Access Compliance Report Public Rights-of-Way (Curb Ramps)

Main Street: TUCKER_LN Cross Street: SILVER_FOX_RD Location: SE

ADA ID: RPRK211208130638 Ramp Type: Type 1 - Perpendicular Diagonal Initial Pass/Fail: Fail Overall Compliance: No Severity Score: 2

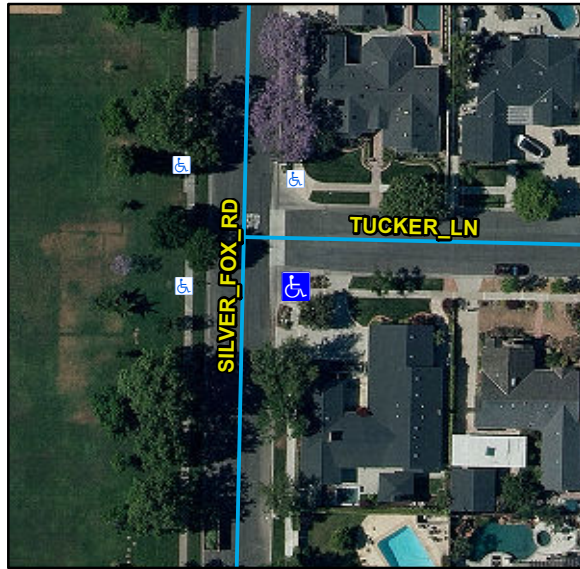
Compliance	Description	Data	Compliance	Description	Data
N/A	Ramp Length (in)	84	N/A	Flare Type LT	
Yes	Ramp Width (in)	48			N/A
Yes	Ramp Run Slope (%)	5.3	N/A	Flare Slope LT (%)	N/A
No	Ramp Cross Slope (%)	2.9	N/A	Flare Traversable LT	N/A
N/A	Landing Present	N/A	N/A	Flare Type RT	
N/A	Landing Length (in)	N/A			N/A
N/A	Landing Width (in)	N/A	N/A	Flare Slope RT (%)	N/A
N/A	Landing Run Slope (%)	N/A	N/A	Flare Traversable RT	N/A
N/A	Landing Cross Slope (%)	N/A	N/A	DWS Provided	N/A
N/A	Landing Movement Obstructed?	N/A	N/A	DWS Contrast	N/A
	Landing Movement Type	N/A	N/A	DWS Length (in)	N/A
N/A	Landing Shared	N/A	N/A	DWS Full Width	N/A
N/A	Clear Space	Yes	N/A	DWS Offset Left (in)	N/A
N/A	Clear Space To Crosswalk (in)	N/A	N/A	DWS Offset Right (in)	N/A
N/A	Marked Crosswalk 1	No	N/A	Marked Crosswalk 2	No
	Crossing 1 Direction	N		Crossing 2 Direction	W
	Marked Crosswalk 1 Width (in)	N/A		Marked Crosswalk 2 Width (in)	N/A

Remove & Replace Curb Ramp With Two New Directional Ramps or Equivalent.

R204.3, R304.5.3, STD 1115
